SAN FRANCISCO PLANNING DEPARTMENT

Preliminary Project Assessment

Date: January 9, 2017
Case No.: **2016-013312PPA**
Project Address: 542-550 Howard Street
Block/Lot: 3721/015A, 031, 016
Zoning: C-3-O (SD)
Transbay C3 SUD
Transit Center C-3-O (SD) SUD
750-S / 450-S
Area Plan: Transbay
Transit Center District
Downtown
Project Sponsor: Cameron Falconer, Hines
101 California Street, Suite 1000
San Francisco, CA 94111
Cameron.falconer@hines.com
Staff Contact: Tina Chang – 415.575.9197
tina.chang@sfgov.org

Bulk: Area Reduction

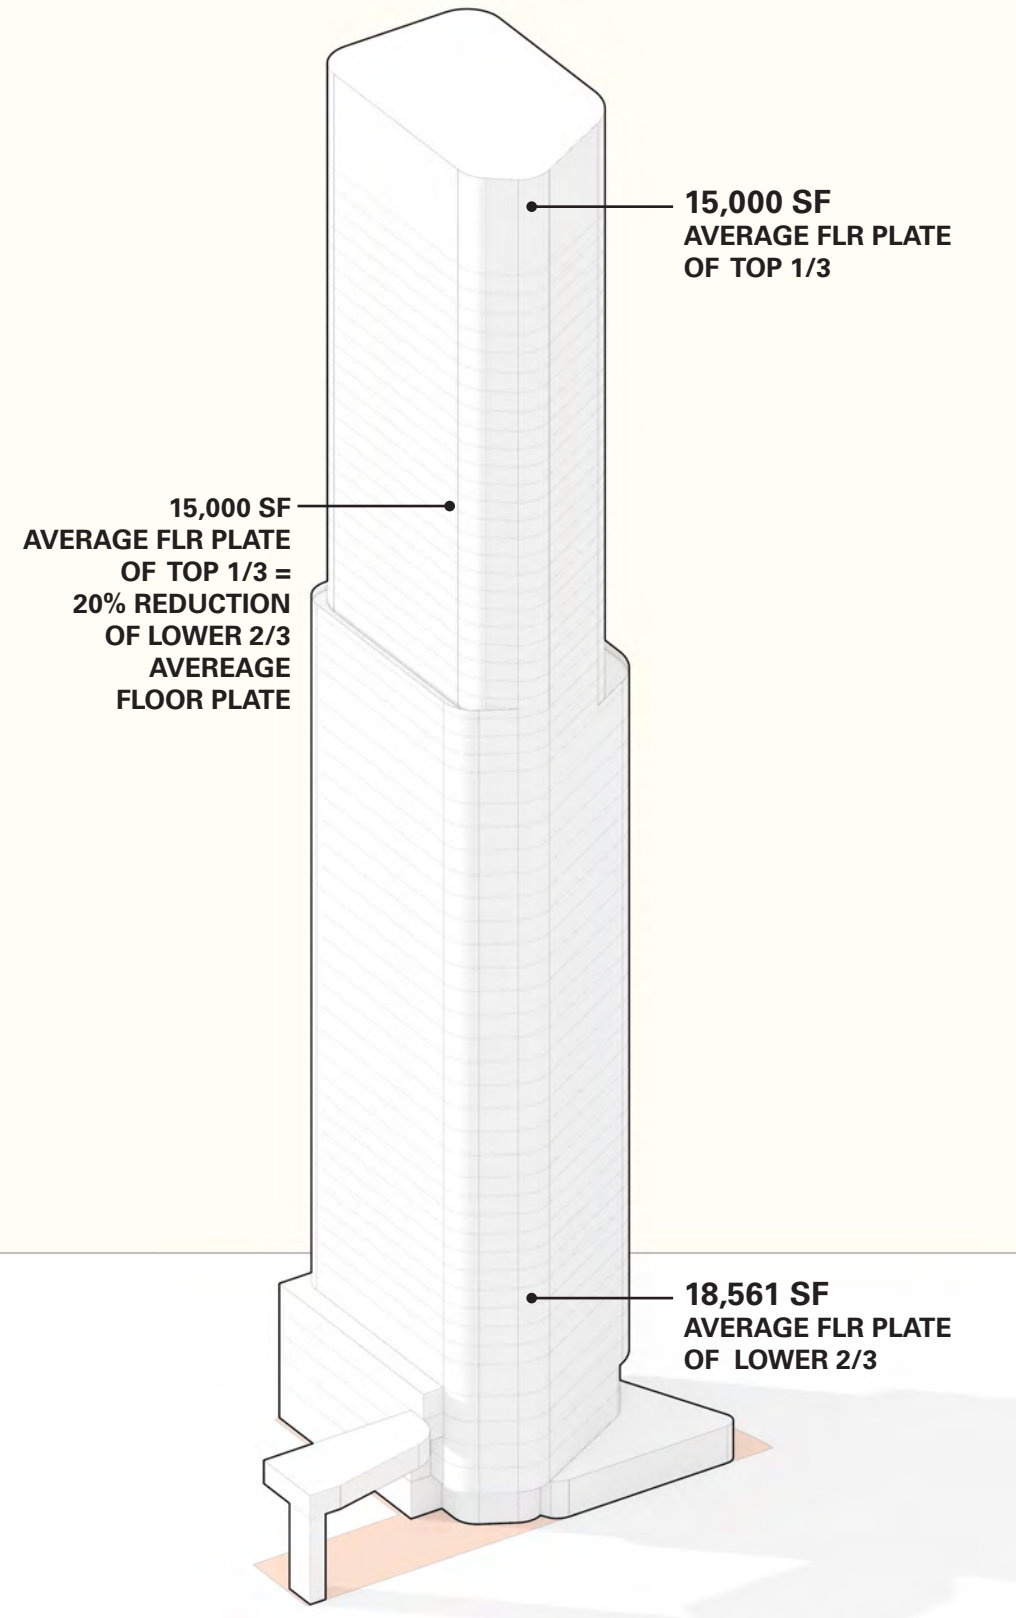
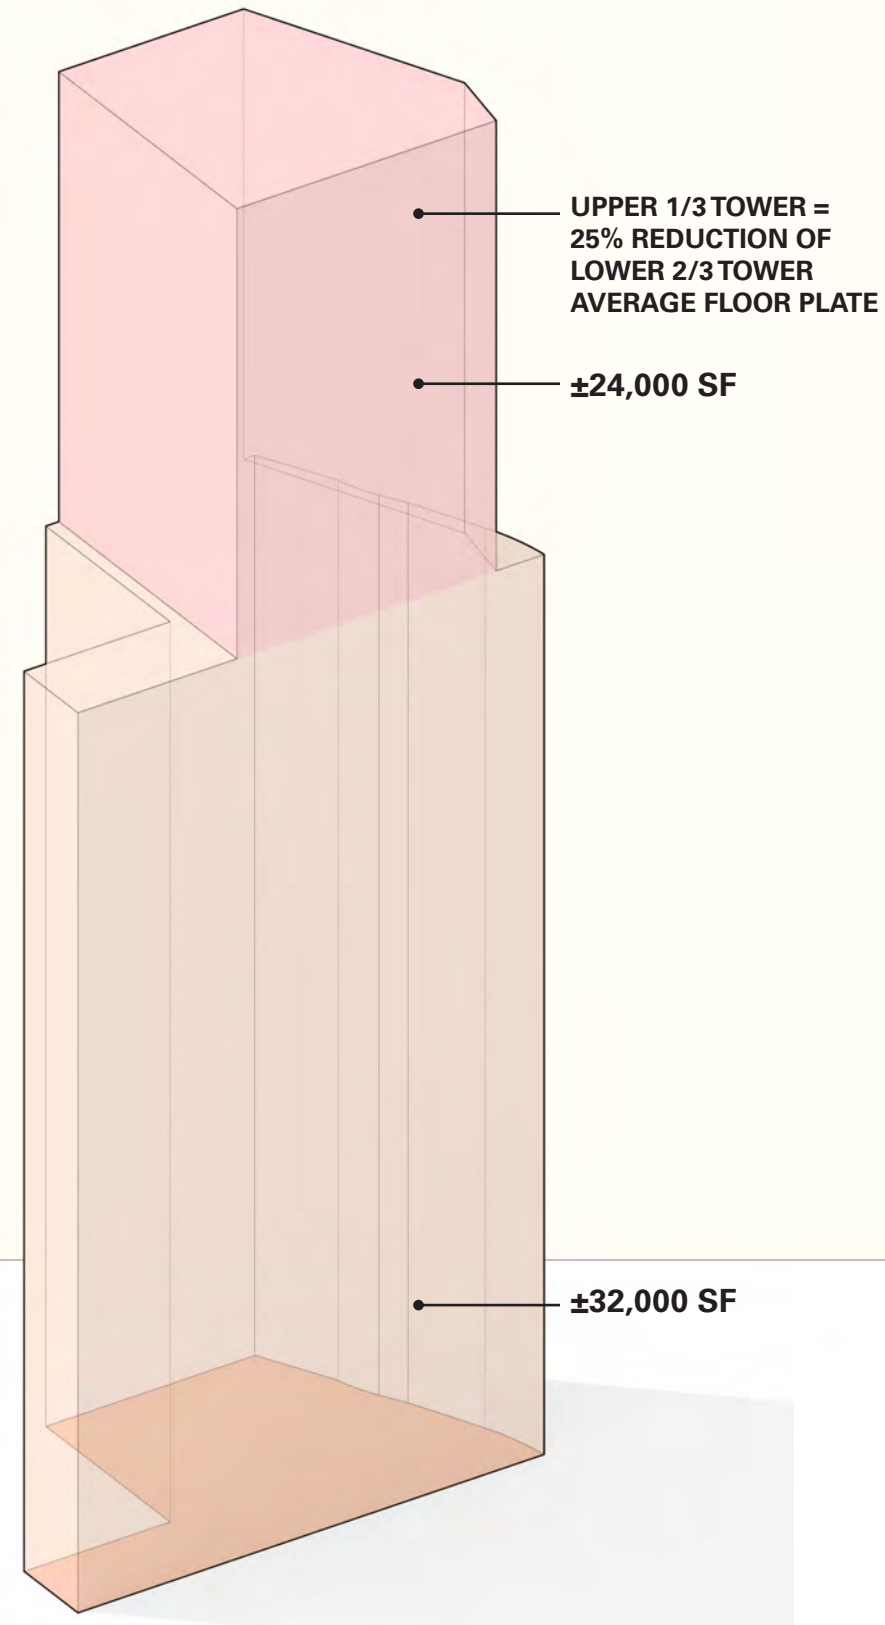
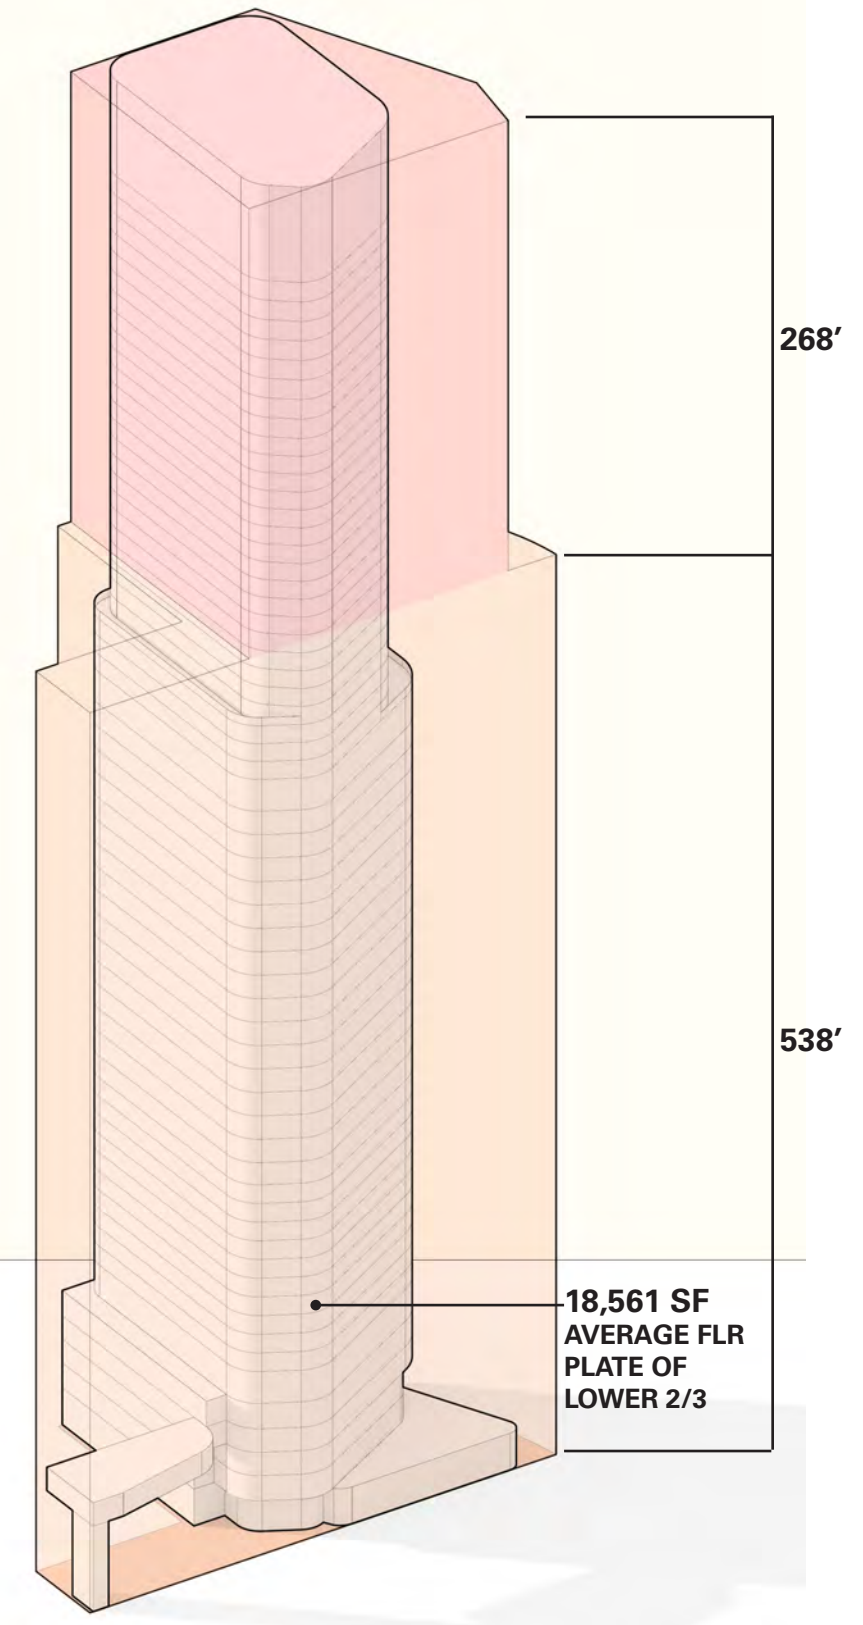
33. **Bulk (Section 270.)** In S-2 Districts, bulk limits are prescribed in Section 270(d). As proposed, it appears that bulk exceptions, pursuant to Planning Code Section 272 and 309 will be required since the upper third of the building exceeds 75 percent of the average floor size of the lower tower, and the average diagonal dimension exceeds 87 percent of the average diagonal dimension of the lower tower. If a bulk exception is being sought pursuant to Planning Code Section 309, please demonstrate that criteria outlined in Section 272(a) have been met.
